CLUB RACING BOARD MINUTES | January 2, 2018

DATE: January 20, 2018

NUMBER: TB 18-02

SUBJECT: Errors and Omissions, Competition Adjustments, Clarifications, and Classifications

Illustration of strut housing modification discussed in section g) 4.

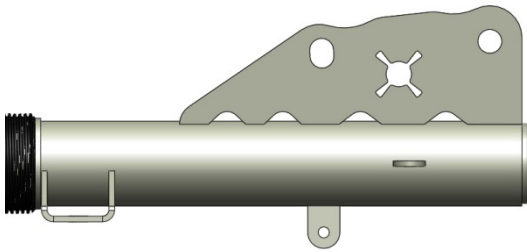
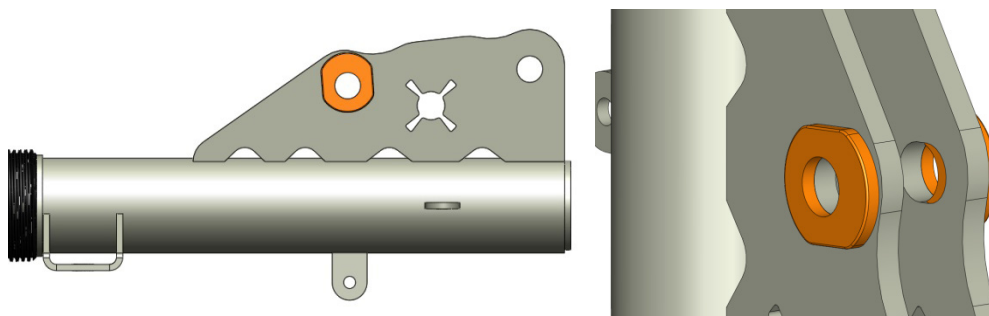
(4) Maximum negative front camber is 3.5 degrees. The approved technique to accomplish this is by using the Cortex P/N CFS-40-ALIGN-SMG, SMG Alignment kit (which includes camber slugs P/N CFS-40-1010), in all SMG strut housings. Installation guidelines are provided by Cortex Engineering. The JRi front strut housing will already have this feature. This CFS-40 kit is allowed, not required. But this IS the only allowed means to go beyond 3.0 degrees of negative camber. Potential tire clearance issues, resulting from this modification, are addressed in Section o). No machining of body to allow further travel. Caster: min. +6.35; max. +7.85. Camber plate PN MM5CC-5 or CCP197-05-09.
